## ADDENDUM No. 3

### RFP No. 26-11

#### N. University and Thayer Improvements

SHEET No. 46 OF 80

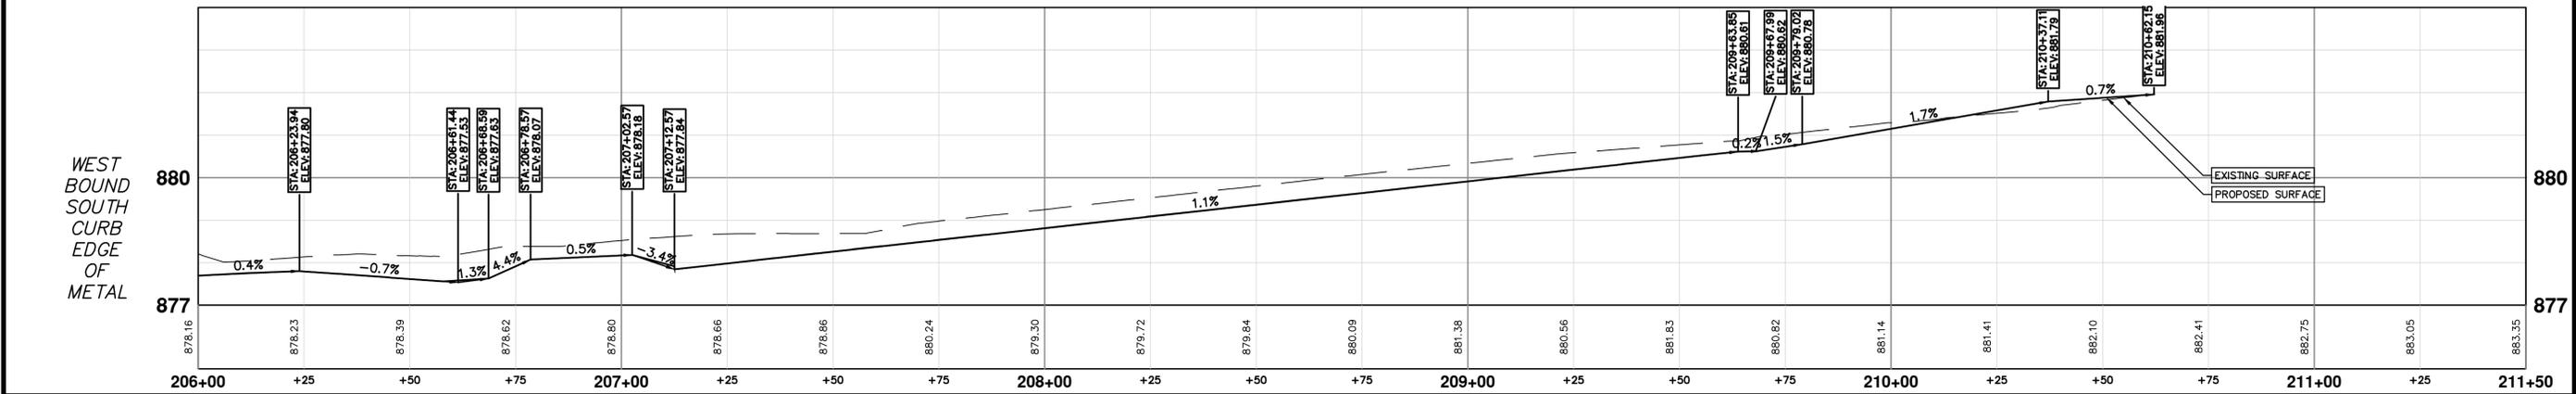
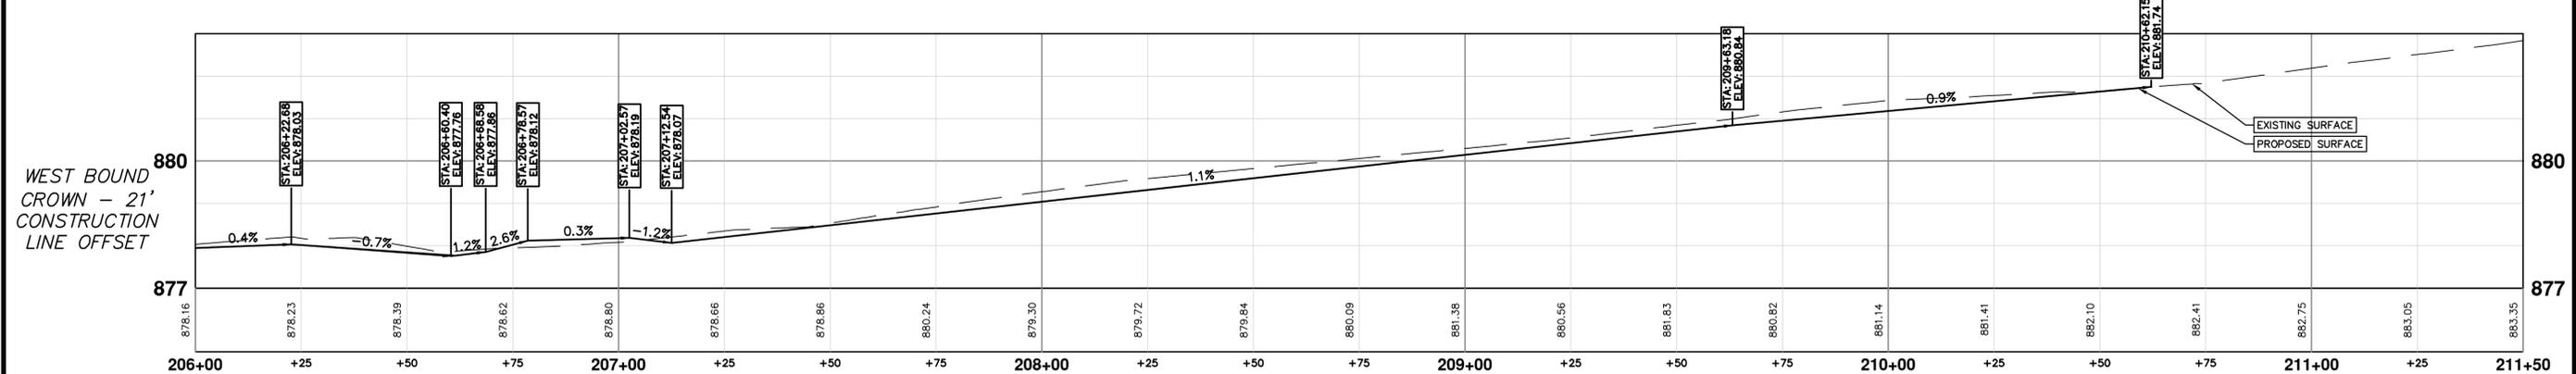
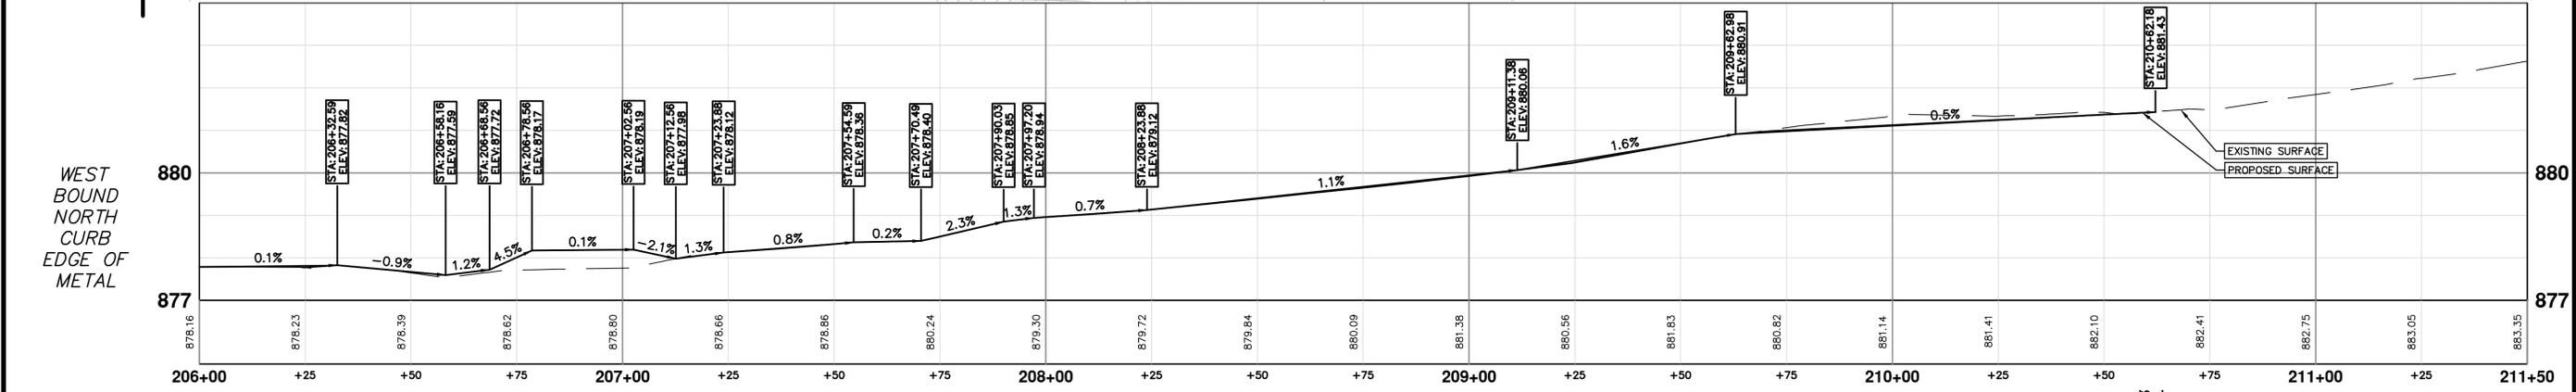
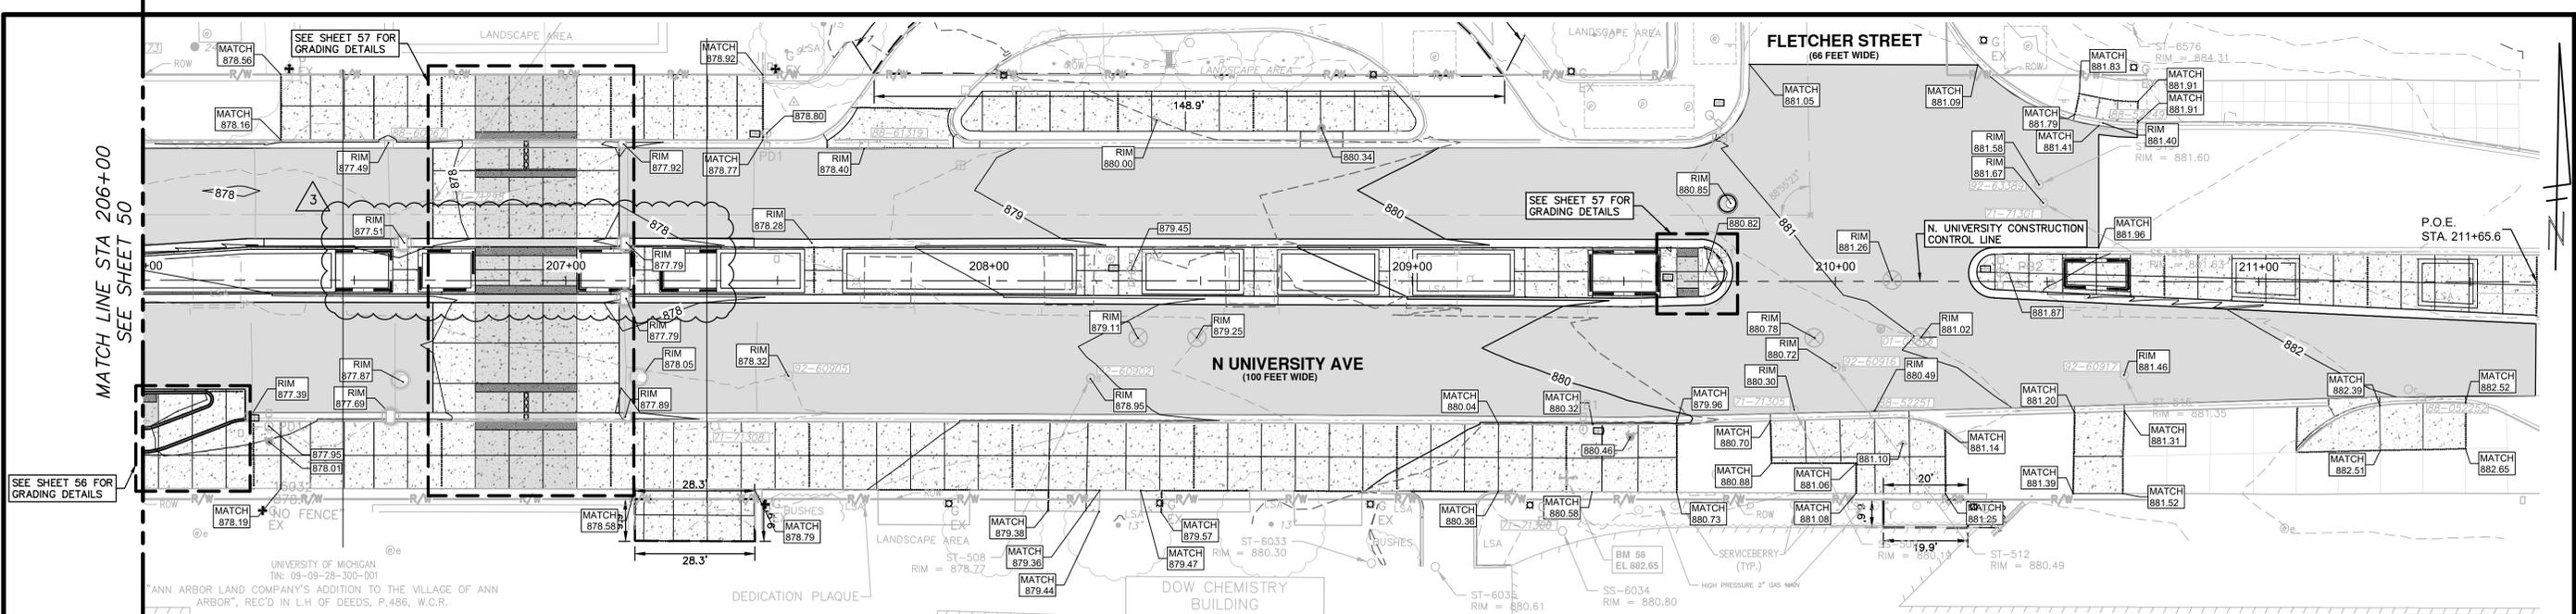
| Plan Sheet 46     | Revisions made to water service lead to Michigan League building.                       |

SHEET No. 52 OF 80

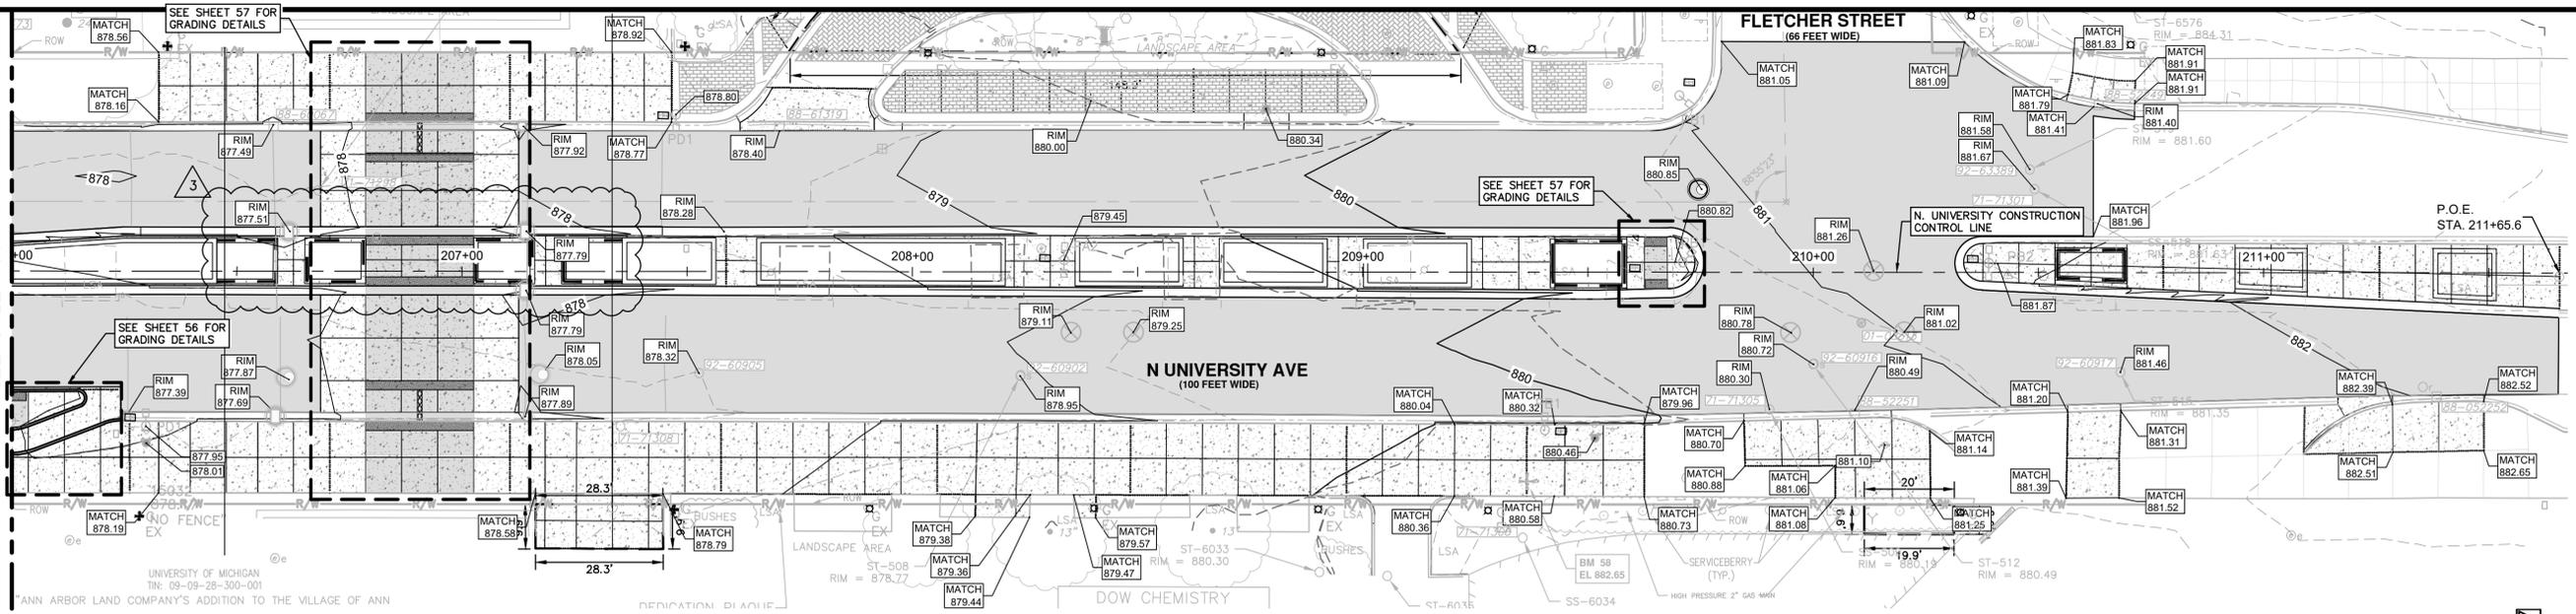
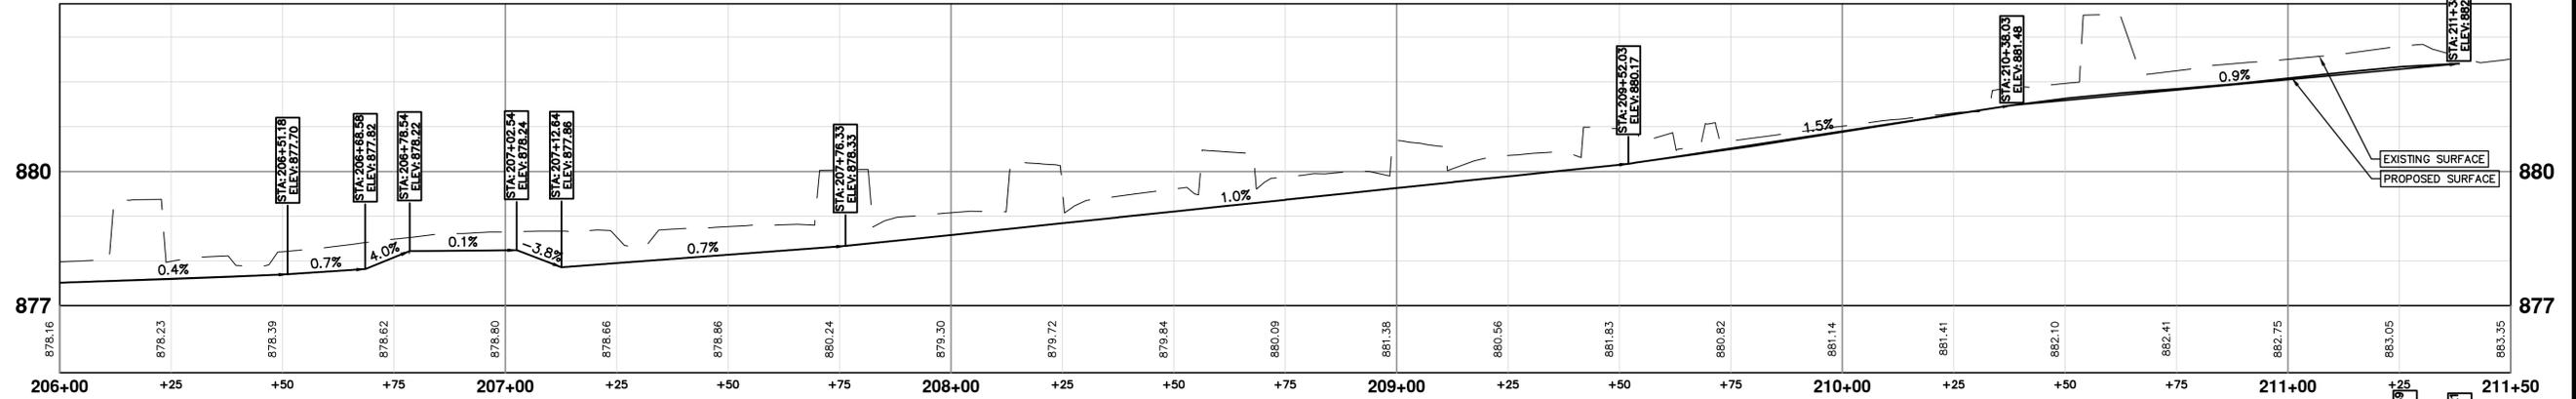
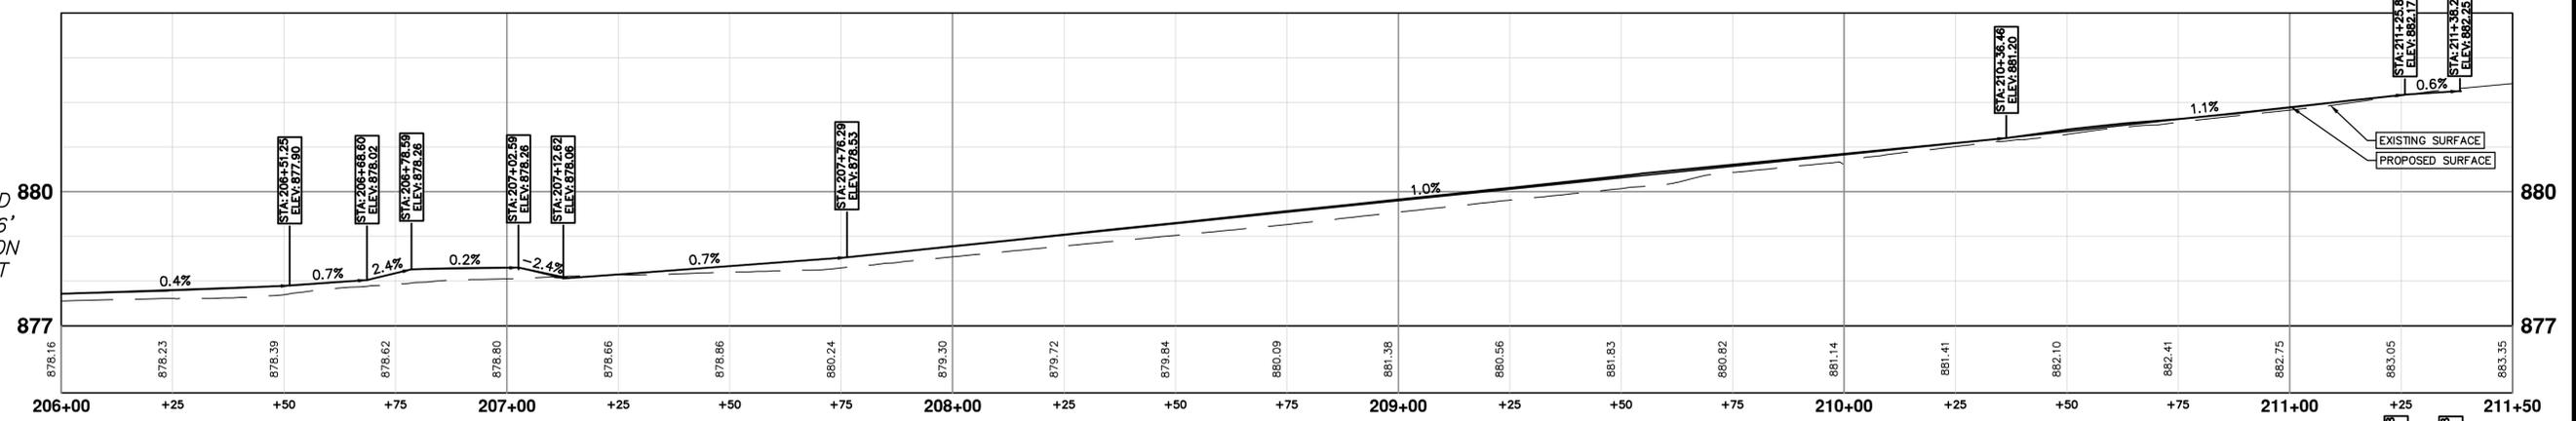
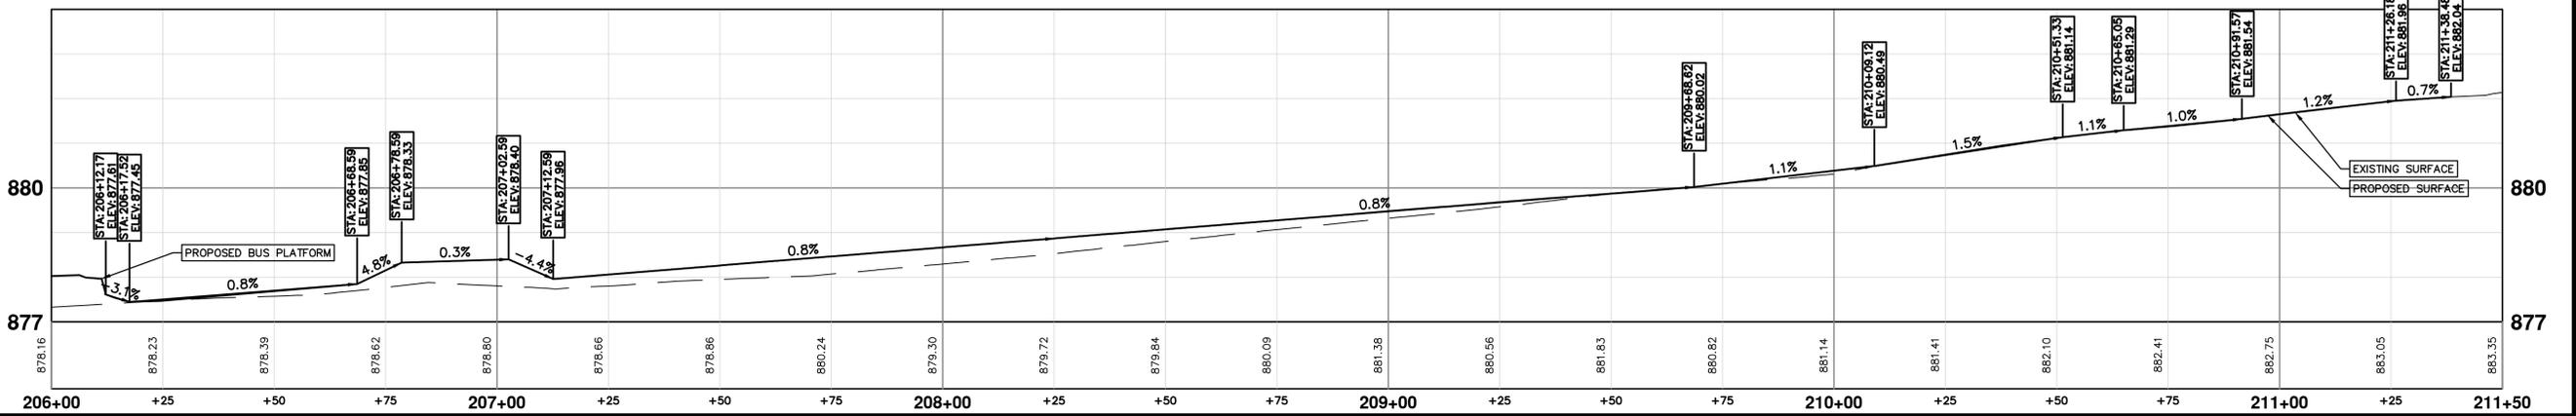
| Plan Sheet 52-53  | Revision of layout of proposed planter boxes.   |
